Proposed editor responses to
clause 72 comments # 177,
97, 115, 130, 52, 64, 65, 114, 129

Tom Palkert
Editor Clause 72
Jan 12 2006

Figure 72-5—Training state diagram

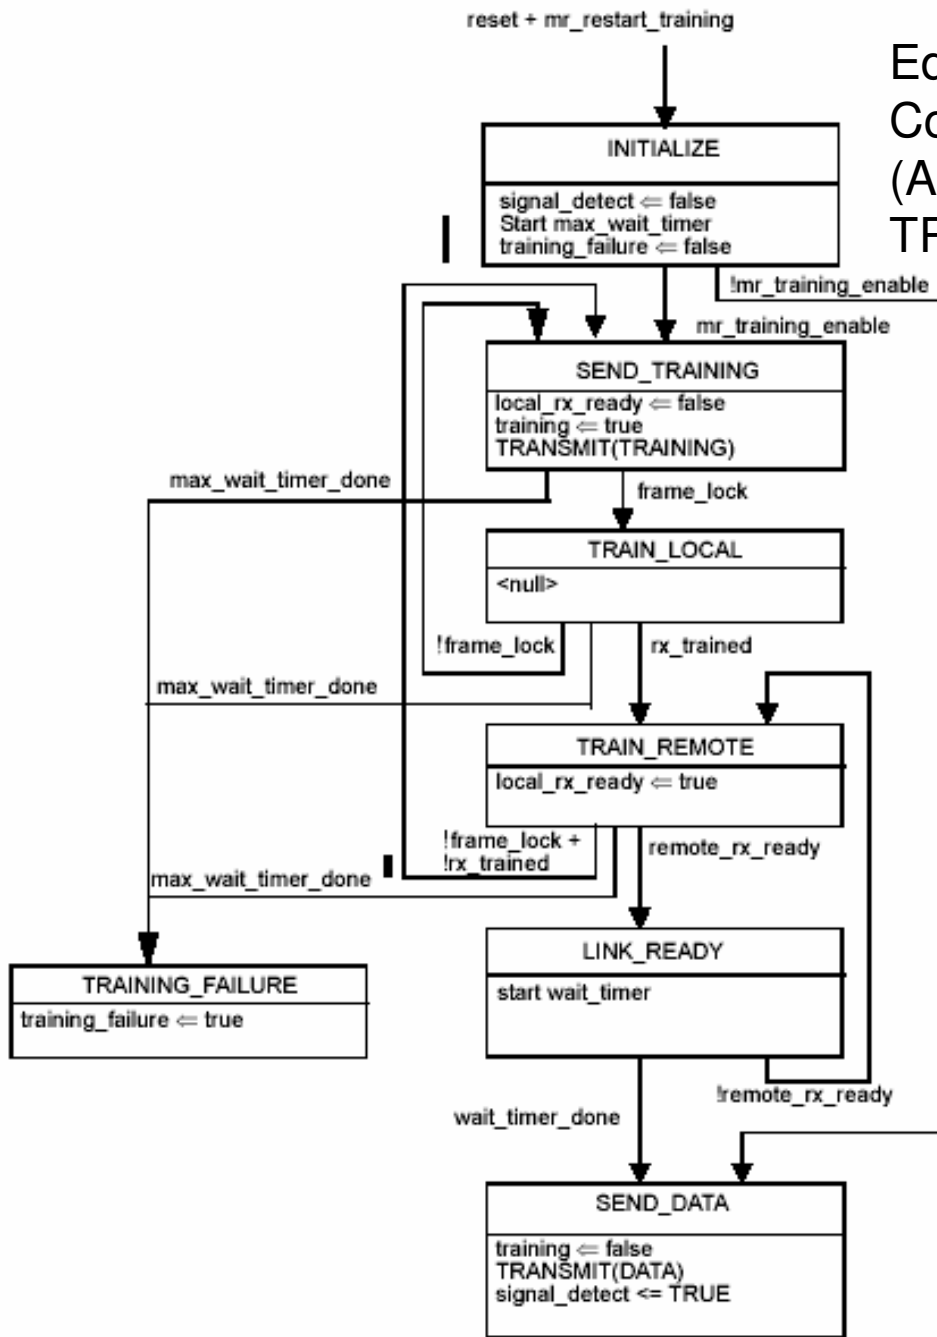
Editors response to
 Comment # 177
 (Added
 TRAINING FAILURE STATE)
